# Service Bulletin

## 2001-2002 GL1800A ABS Speed Sensor Wire Clamp Location

**GL1800 #9  
DECEMBER 2001**

**INCORRECT Installation**

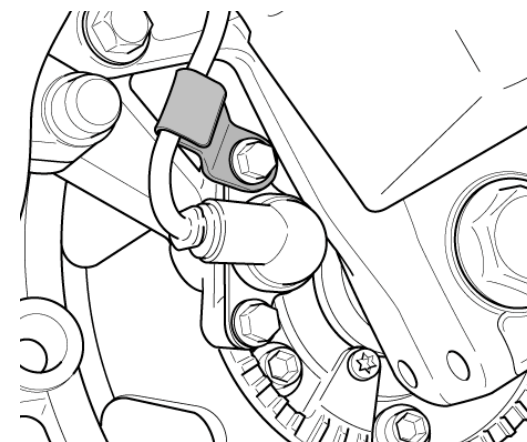
If the speed sensor wire clamp for the front ABS speed sensor is installed incorrectly, the ABS speed sensor air gap may be out of specification. This does not affect ABS speed sensor operation, but the clamp should be installed correctly.

1. If the VIN is within the preceding range, inspect the front ABS speed sensor wire clamp according to the following illustrations.

2. If the clamp is installed correctly on **top** of the speed sensor, no further action is necessary.

3. If the clamp is installed incorrectly **under** the speed sensor, remove and reinstall the clamp and speed sensor correctly. Torque the bolts,.

**Torque: 12 N•m (1.2 kgf•m, 9 lbf•ft)**
